CITY OF MARLBOROUGH MEETING POSTING RECEIVED

Planning Board

August 22, 2022

Definitive Subdivision Plan

PETTES DRIVE SUBDIVISION LOTTING PLAN OF LAND IN MARLBOROUGH, MA OWNED BY JAMES CHAOUSIS

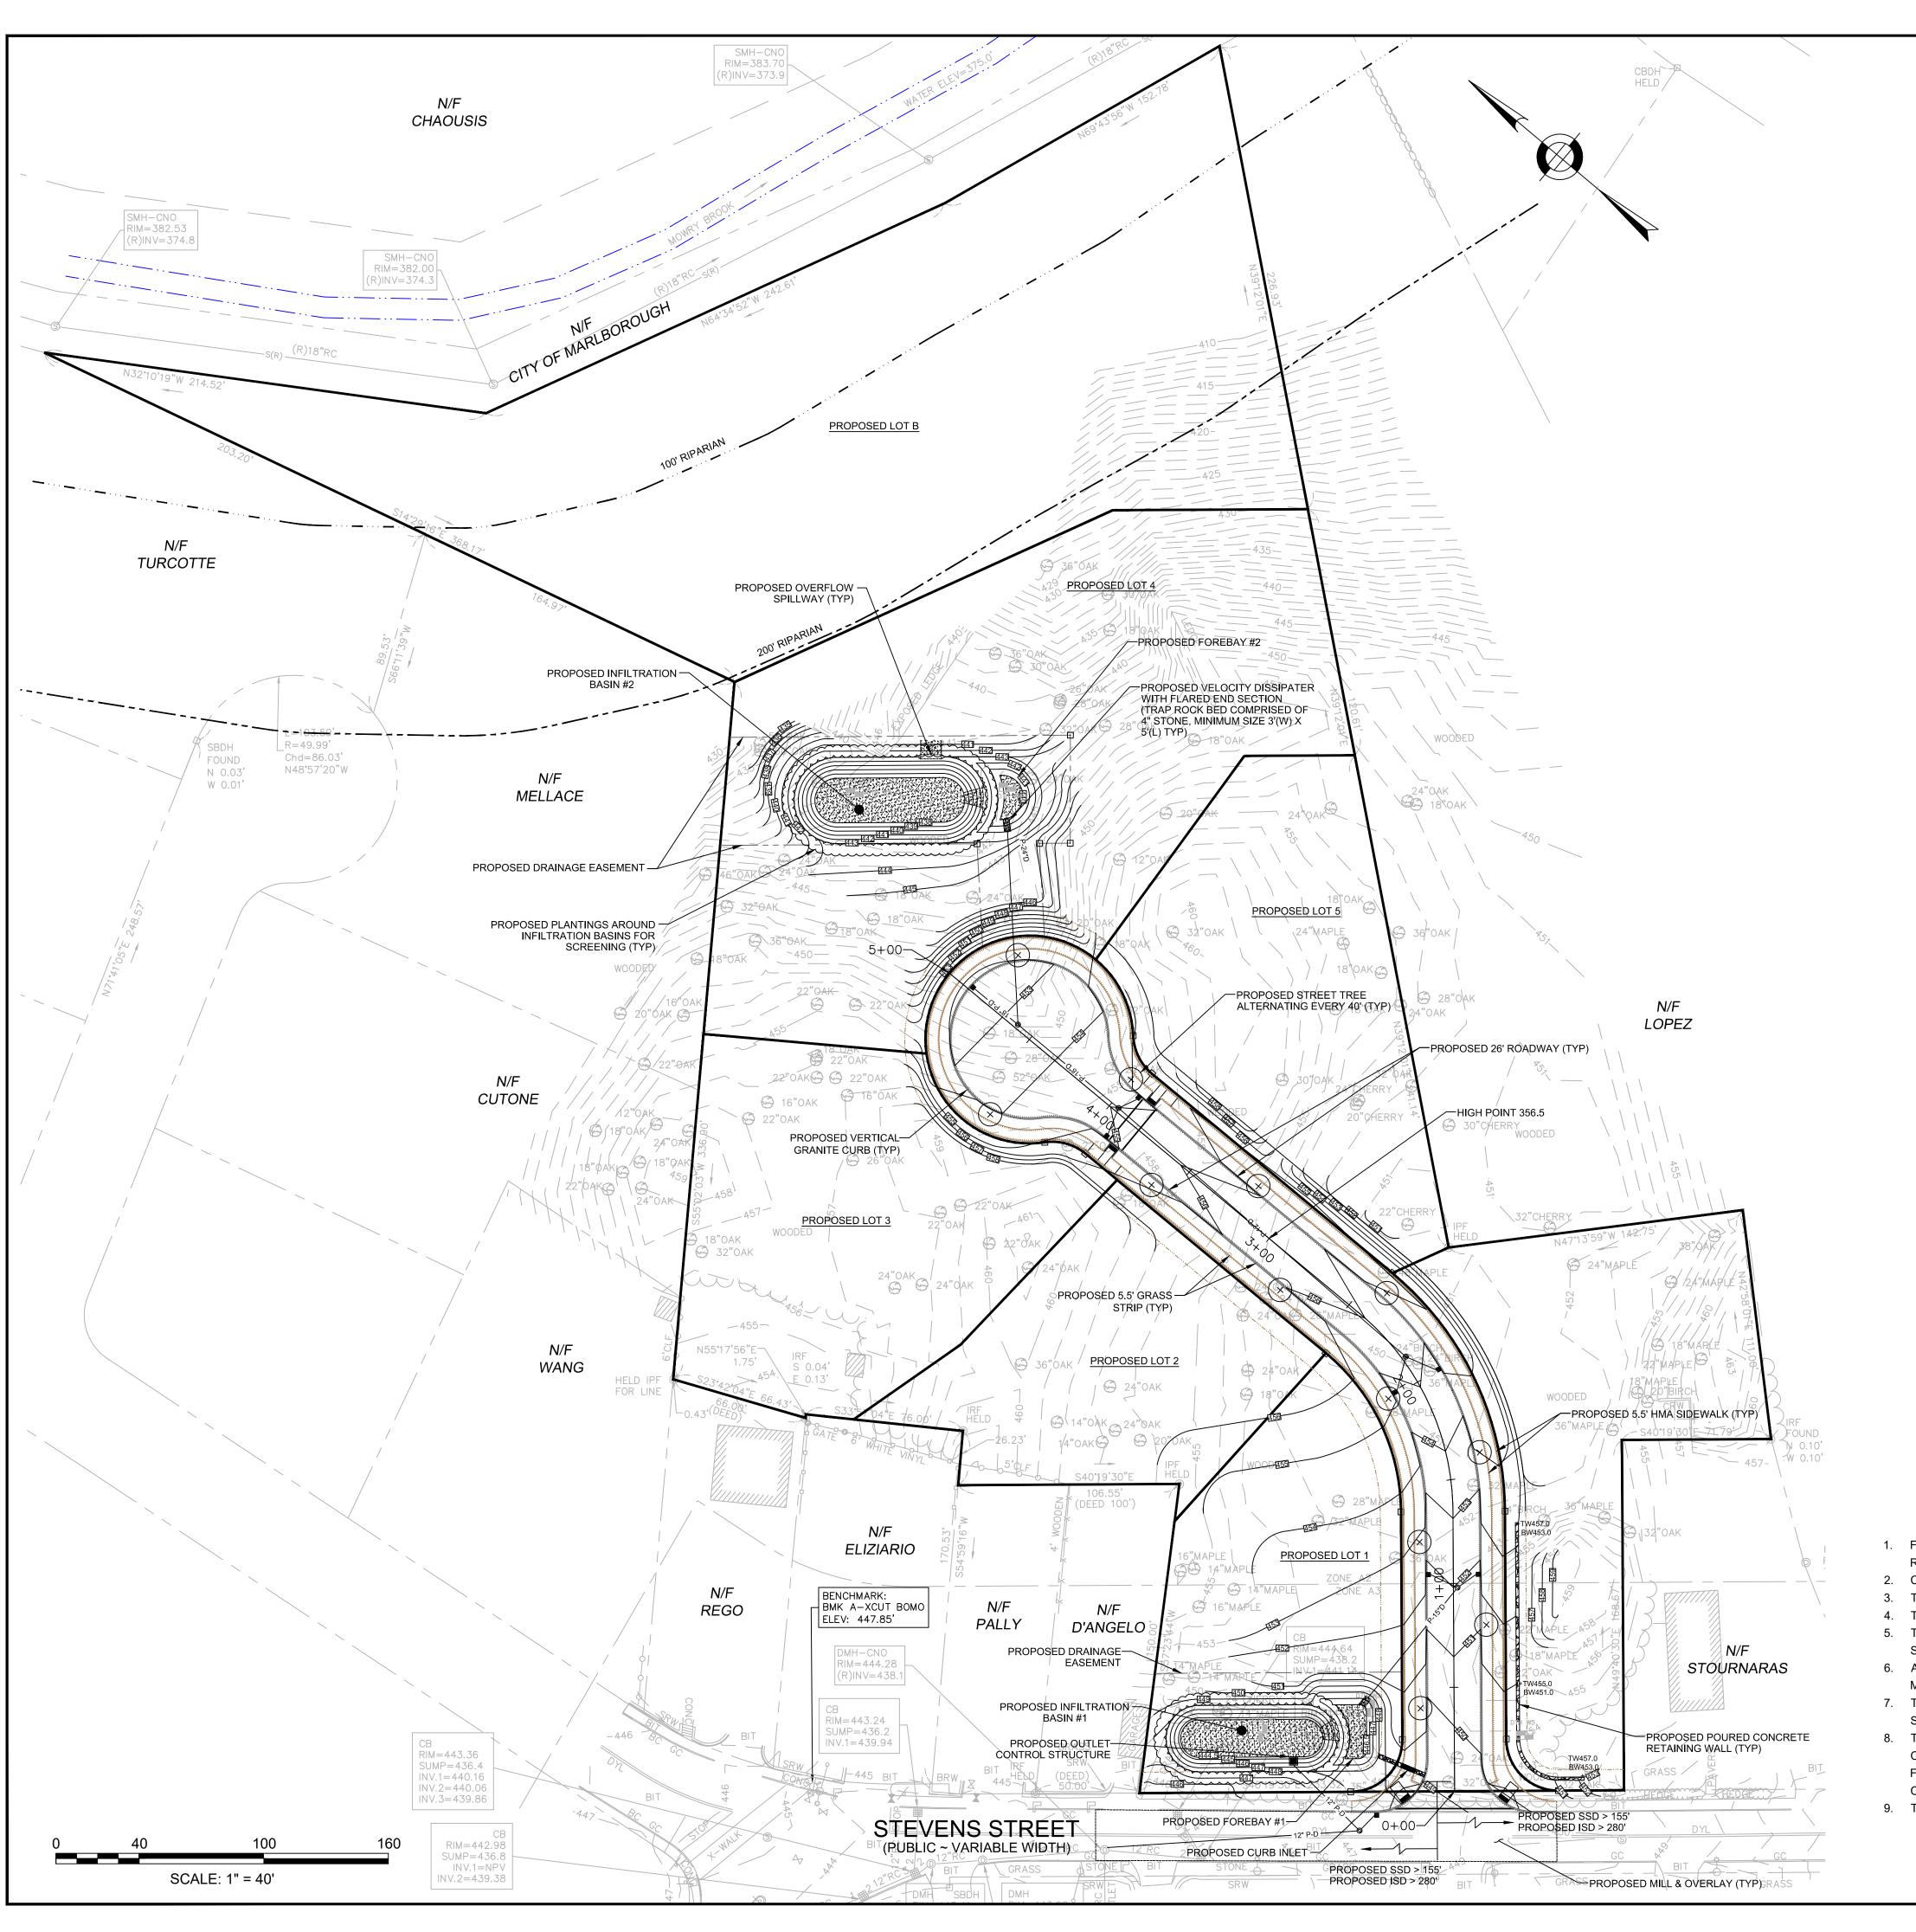
Sheet C-001 Lotting Plan

- 5 As noted above the lot shape Rectangles are incorrect.
- 6 Proposed Lot 4 is not labeled.
- 7 Roadway stationing should be provided, showing dimensions to the radius point of the cul-de-sac and the overall length of the road.
- 8 The area of the proposed easements should be provided.
- 9 Proposed easements should be bounded at the angle points.
- 10 The drainage easement on Lot 4 is shown as 20 feet wide. It should be revised to 30 feet wide.
- 11 Proposed "Lot B" should be called "Parcel B", as it is not a buildable lot.
- 12 "Proposed Zoning Easement" shown in the legend is not applicable and should be removed.

- 1. The proposed street has been renamed to Pettes Drive.
- 2. The planning board block has been revised.
- 3. The lot shape rectangles have been revised.

- 4. A letter from the Arborist has been attached to this submission.
- 5. See response #3.
- 6. Lot 4 has been labeled.
- 7. Stationing and other elements have been added.

- 8. Areas have been provided.
- 9. Bounds have been added.
- 10. Wide of easement revised.
- 11. Lot B has been changed to Parcel B.
- 12. This should have read "Proposed Drainage Easement" and has been changed to such.

PETTES DRIVE SUBDIVISION CONCEPTUAL SITE PLAN OF LAND IN MARLBOROUGH, MA OWNED BY JAMES CHAOUSIS

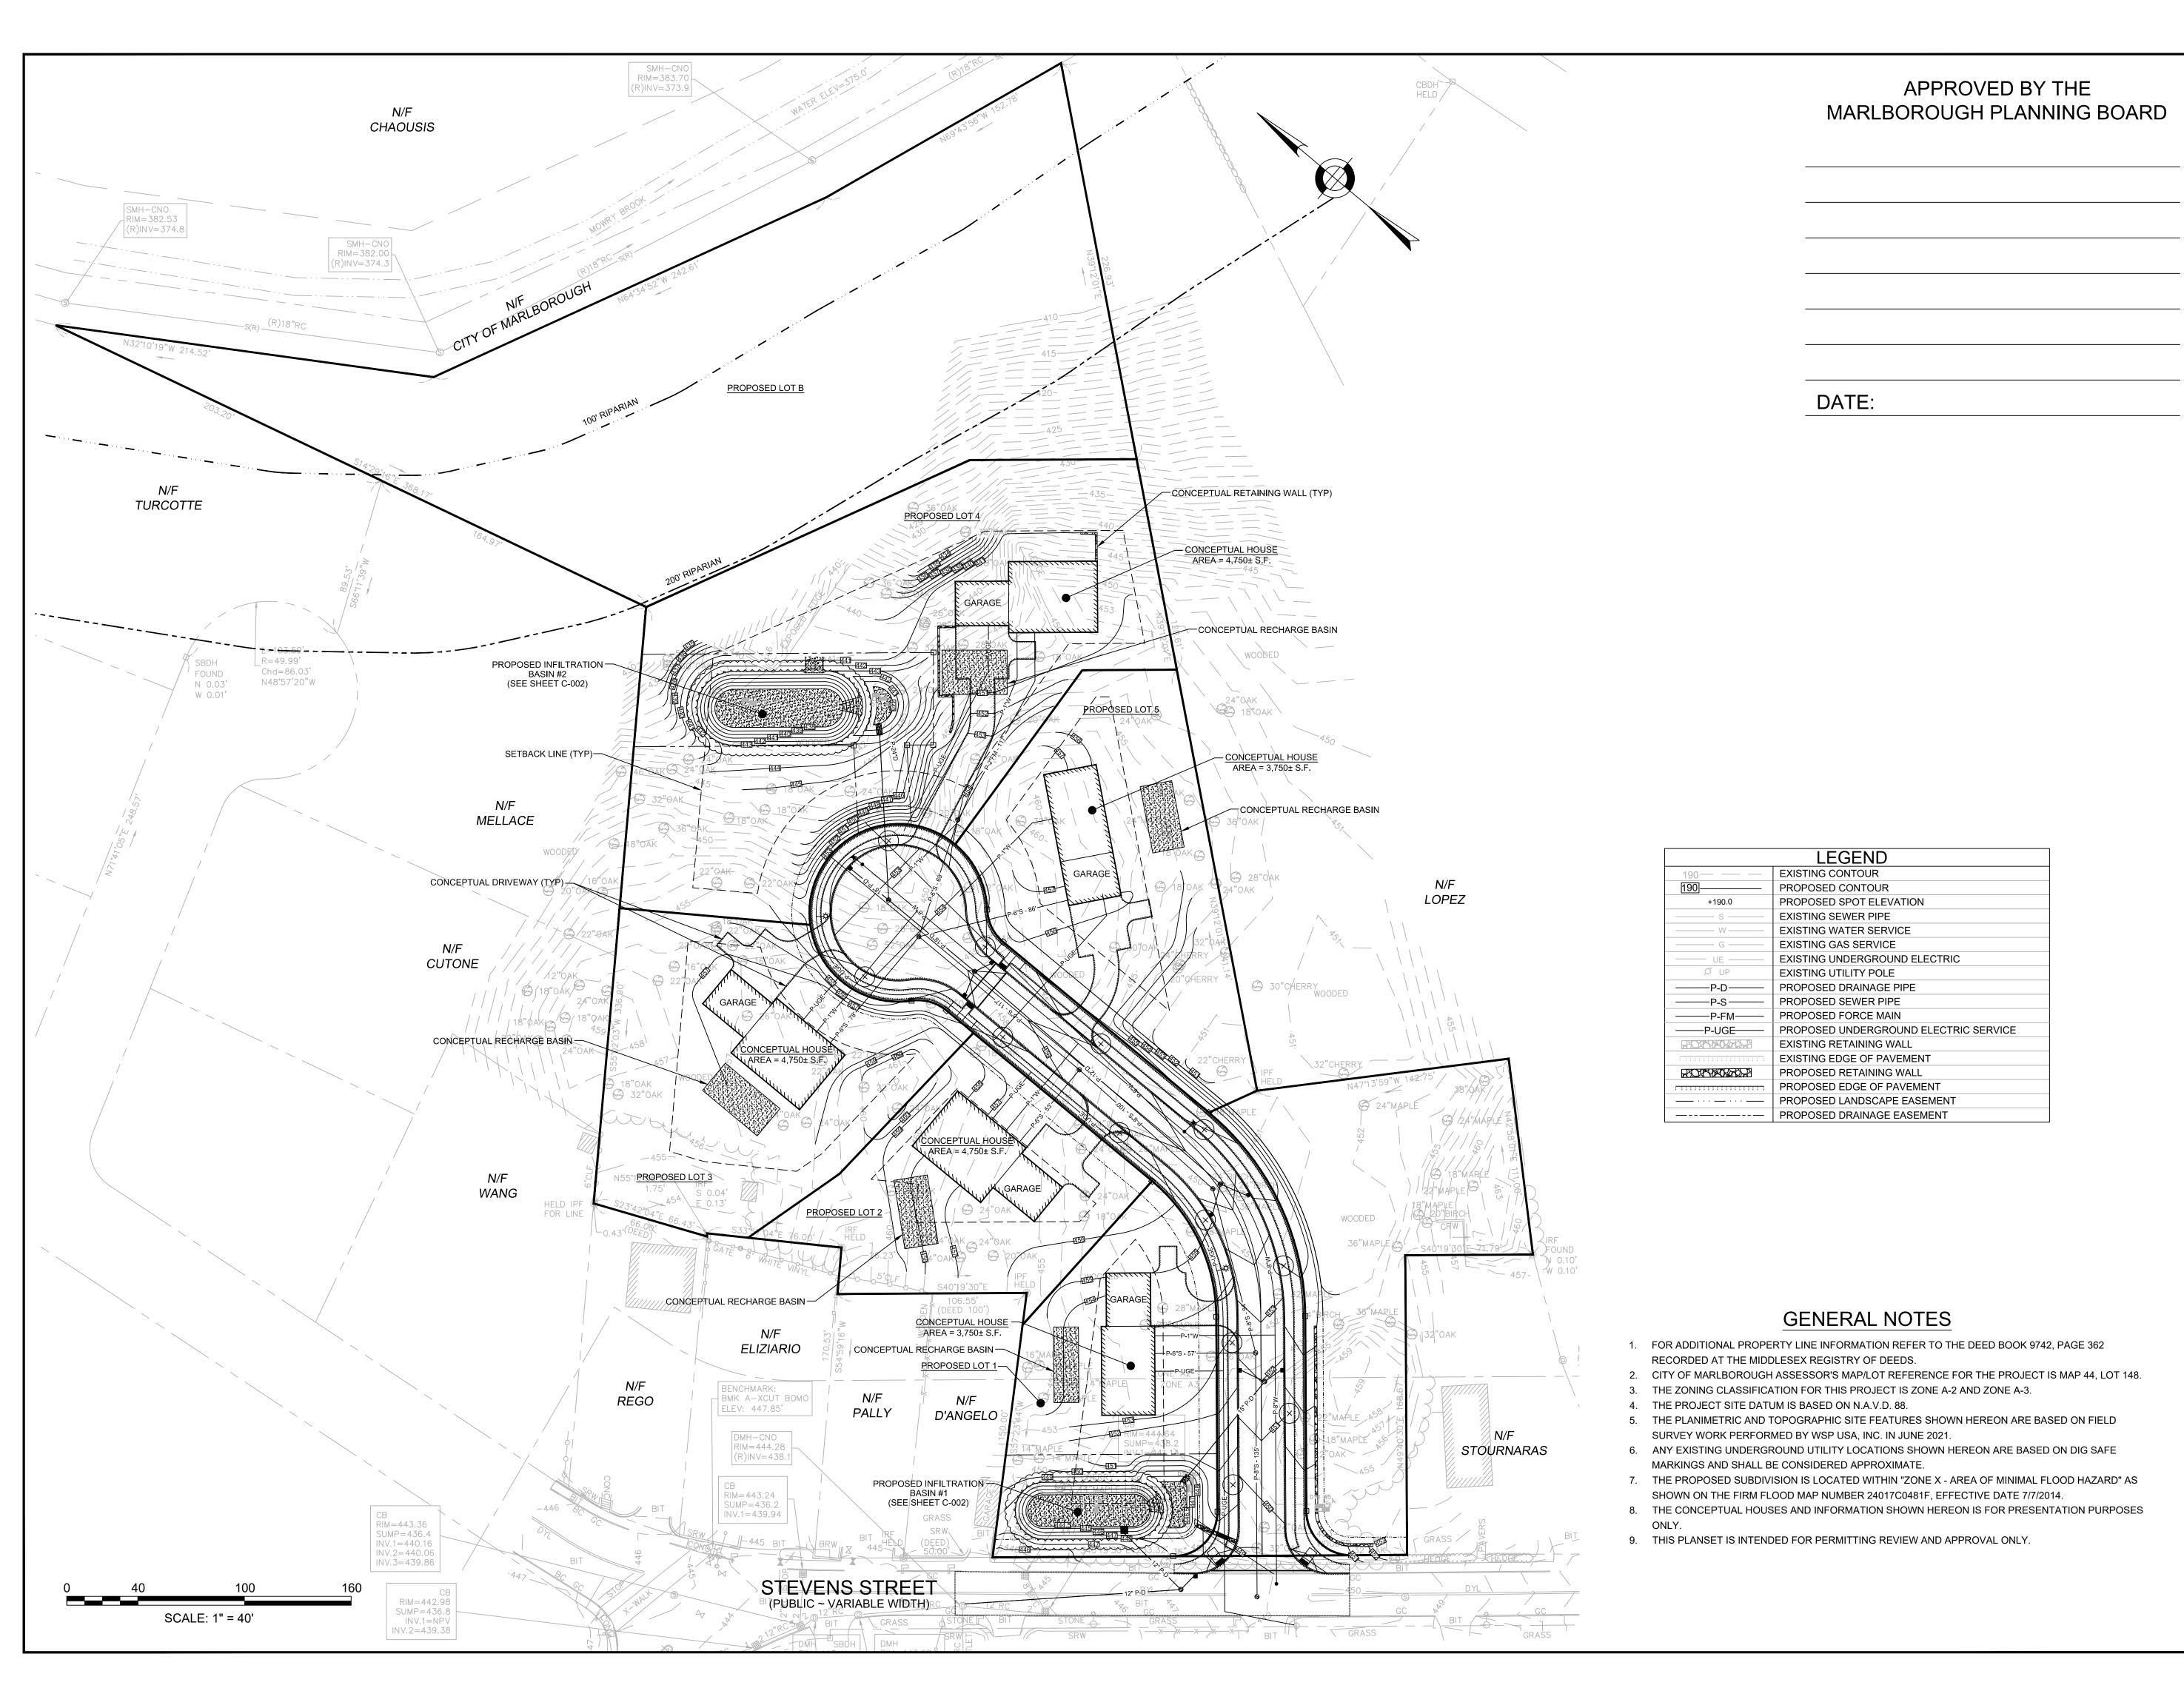
- 13 Proposed houses and driveways, and lot grading back to the house line, should be shown schematically on each lot.
- 14 The proposed grading does not reflect that the roadway will have curbing. This should be revised and the curbing should be called out with the material indicated.

- 13. A conceptual site plan showing all of the requested data has been added to the plan set.
- 14. Roadway grading has been revised to reflect the curb.

PETTES DRIVE SUBDIVISION **EROSION CONTROL PLAN** OF LAND IN MARLBOROUGH, MA OWNED BY JAMES CHAOUSIS

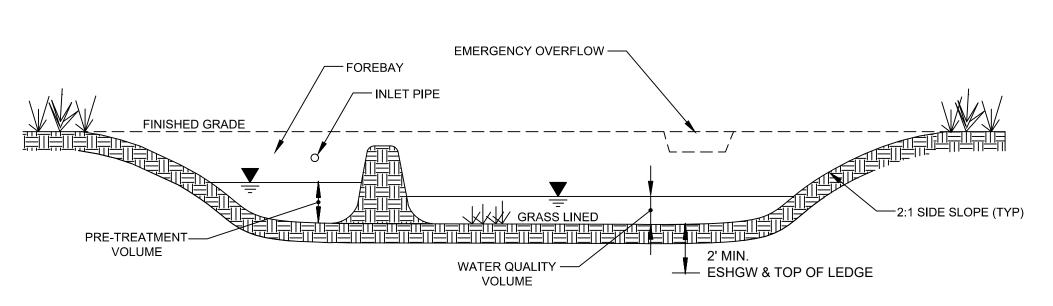
Sheet C-004 Erosion Control Plan

- 38 Proposed stockpile area(s) should be shown.
- 39 Temporary sediment basins to be used and maintained during construction should be shown. The areas of the proposed infiltration basins should not be used for temporary sediment basins during construction, or if it is unavoidable, specifications should be provided on the plans to ensure that the native soil at those locations is not made suitable for infiltration upon completion of construction.
- 40 Proposed tree clearing limits should be shown.
- 41 Construction dewatering specifications should be provided.
- 42 Notes regarding construction sequencing as it relates to erosion control and site stability, should be provided.

- 41. Construction dewatering detail and specs have been added.
- 42. Construction sequencing has been added. Erosion control barrier details were provided on the Stormwater and Erosion Control Report.
